# **ADDENDUM NUMBER 3:**

## **CITY OF PORTSMOUTH, NEW HAMPSHIRE MULTI-PURPOSE RECREATION FIELDS & REGIONAL STORMWATER TREATMENT SYSTEM PROJECT**

**Issued: May 15, 2020  
For Bids Due: May 19, 2020**

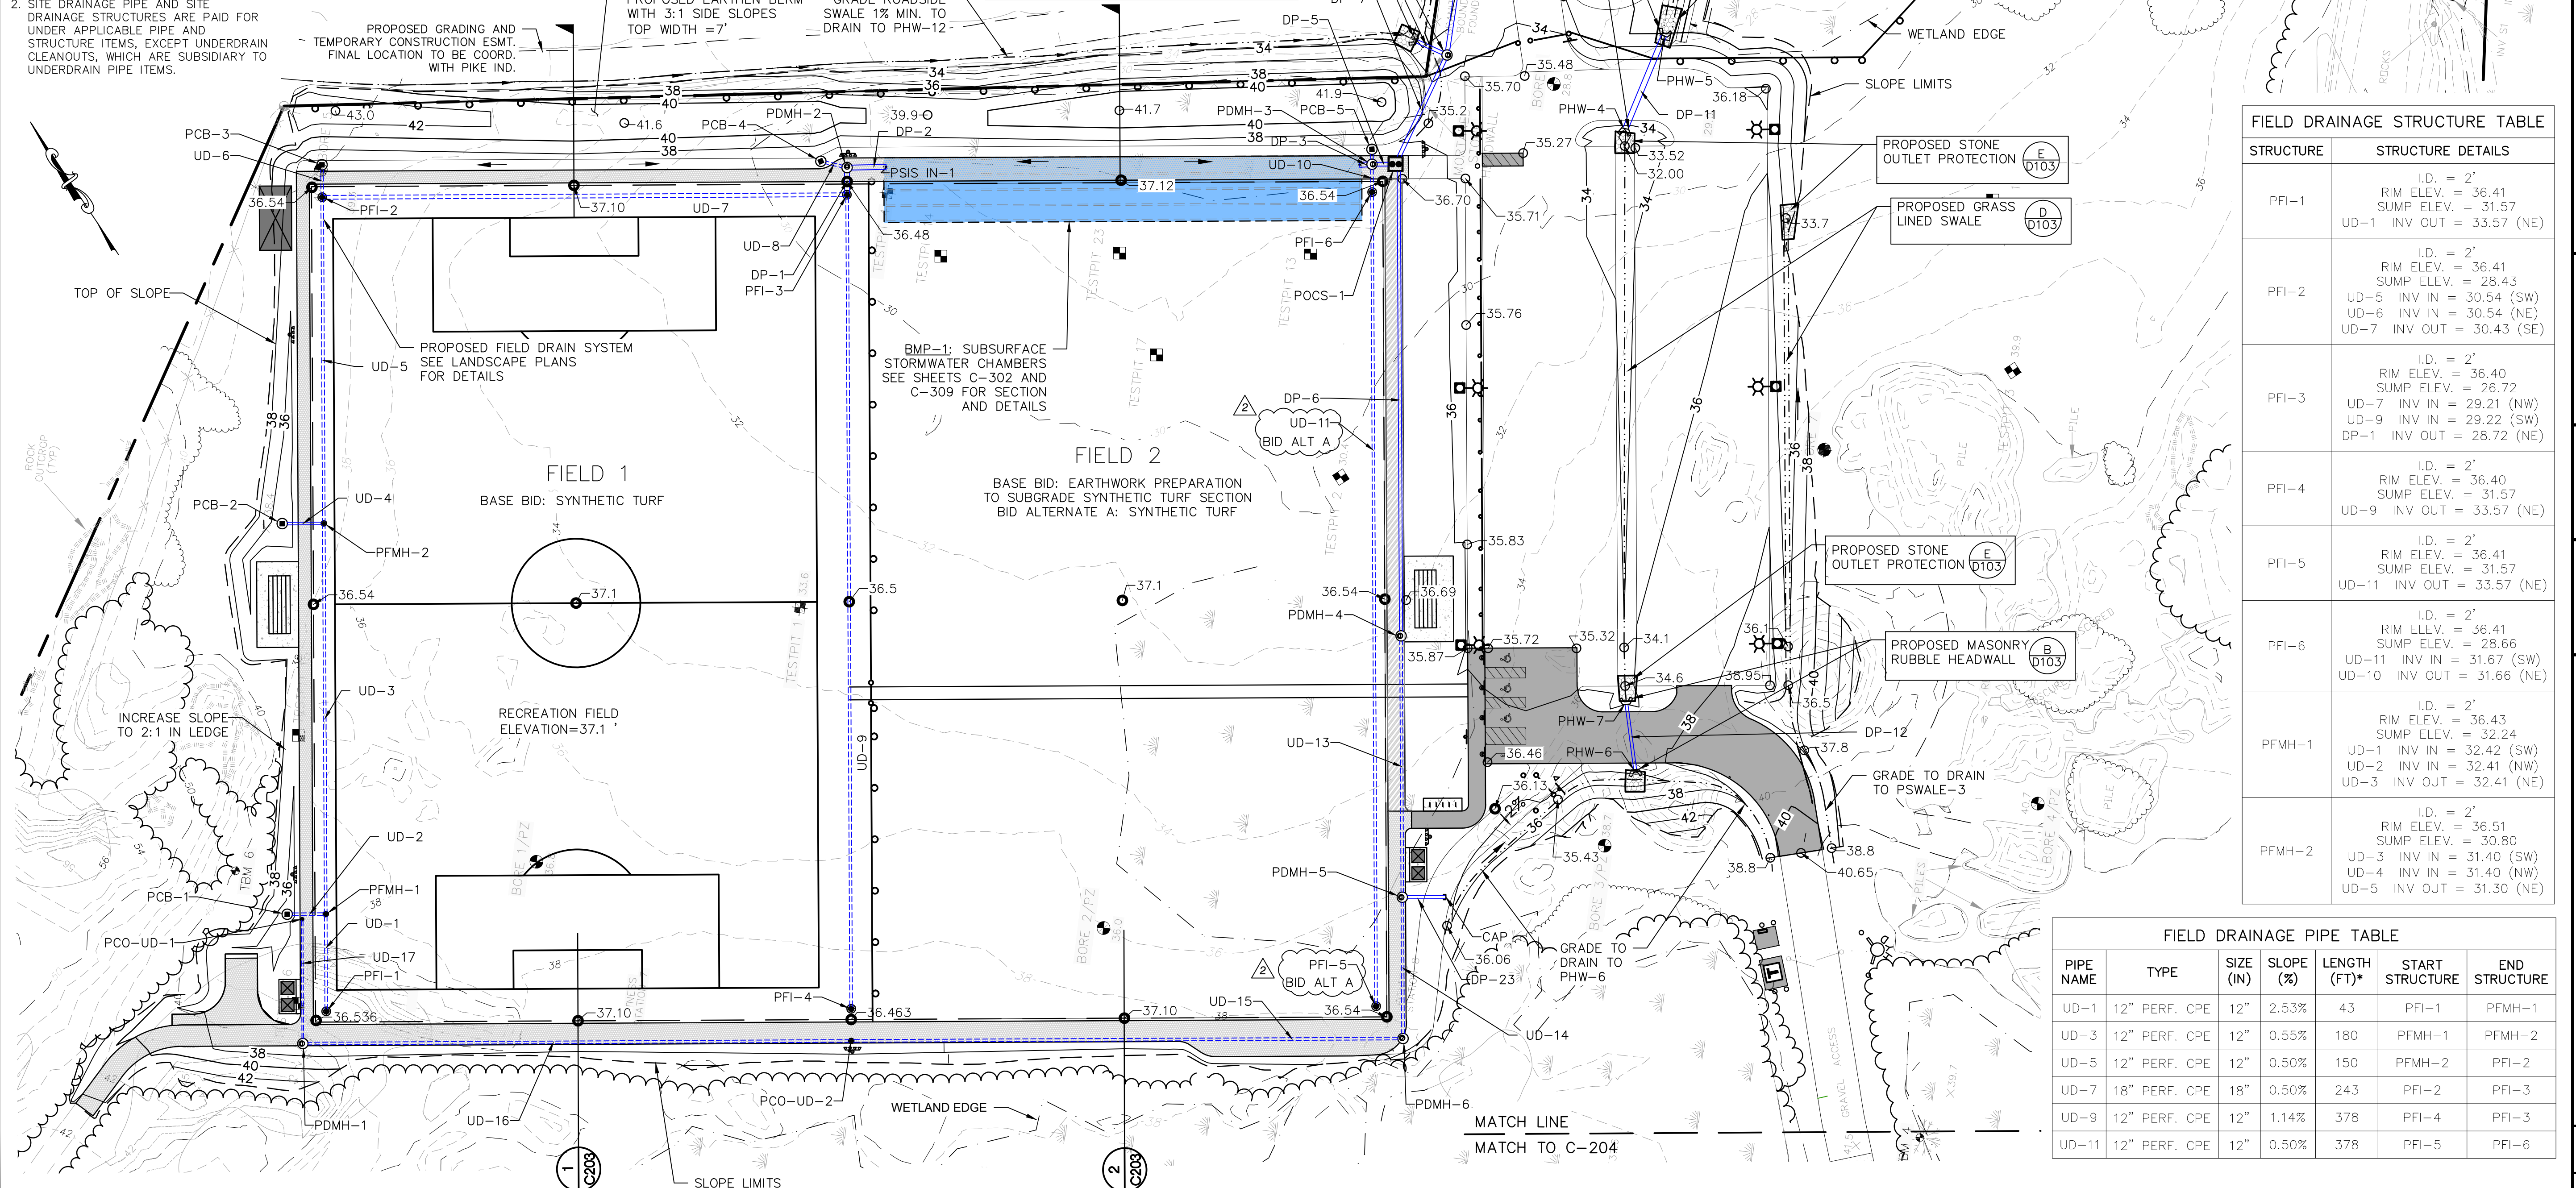
- a. Pipe UD-11 and field structure PFI-5 shall be included in Bid Alternate A, not the base bid. The cost for this pipe and structure shall be included in bid item A1 – Field 2 Synthetic Turf Field.
- b. In plan view, the label for pipe DP-13 shall be revised to DP-22. In the Site Drainage Pipe Table for pipe DP-22, the start structure shall be revised to PHW-12 and the end structure shall be revised to PDMH-7. See attached revised plan.

**Response:** In plan view on sheet C-202, pipe DP-13 should be labeled DP-22. The pipe information for pipe DP-22 in the Site Drainage Pipe Table is correct; the start structure shall be revised to PHW-12 and the end structure shall be revised to PDMH-7.

**Response:** PFI-5 and UD-11 shall be included in Bid Alternate A, not the base bid. Per this addendum, sheet C-202 has been revised to reflect this configuration.

**1** WOOD GUARDRAIL  
SCALE: NTS

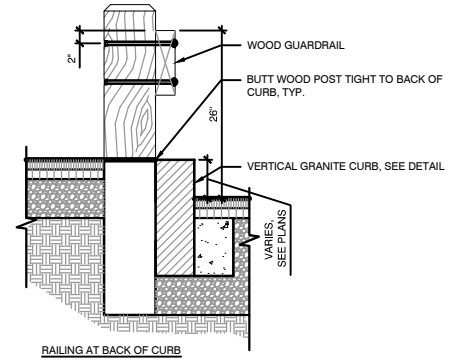
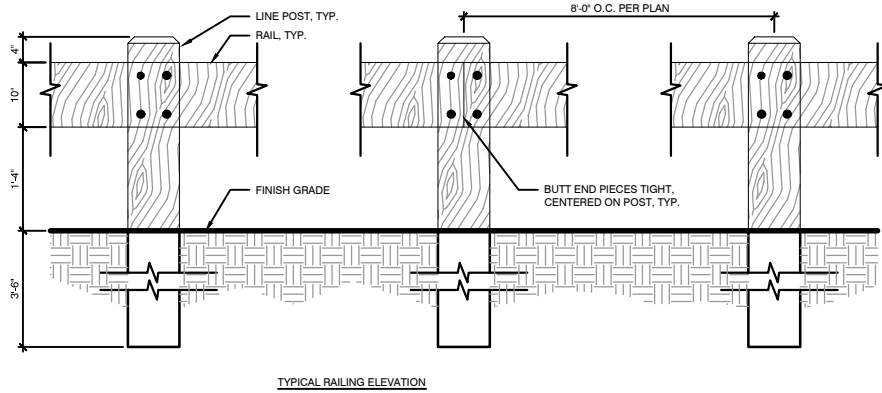
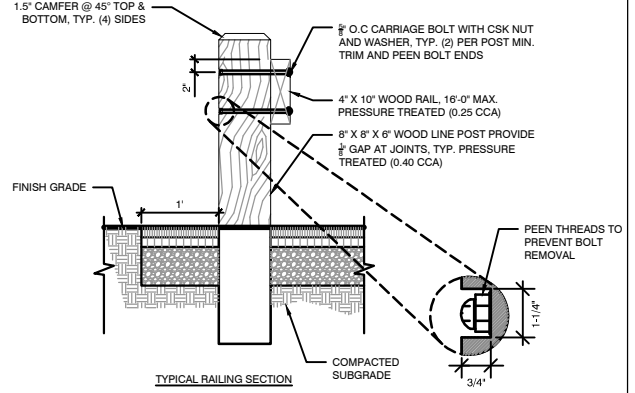
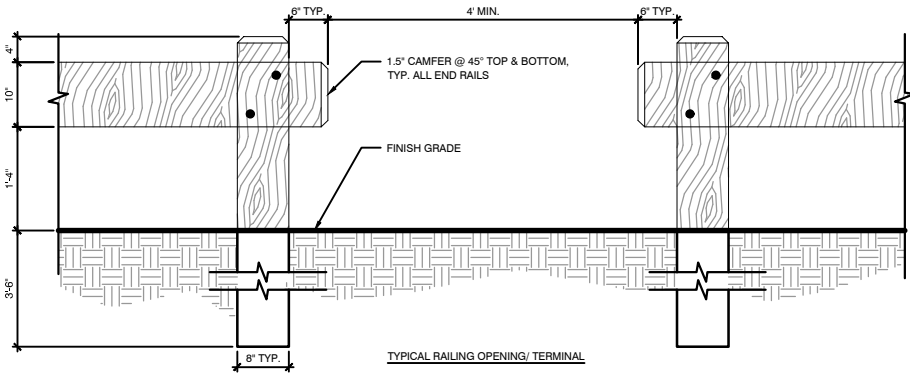
24. Sheet C-201- Please provide detail for Wooden Guardrail.

**Response:** See attached detail SK-1.
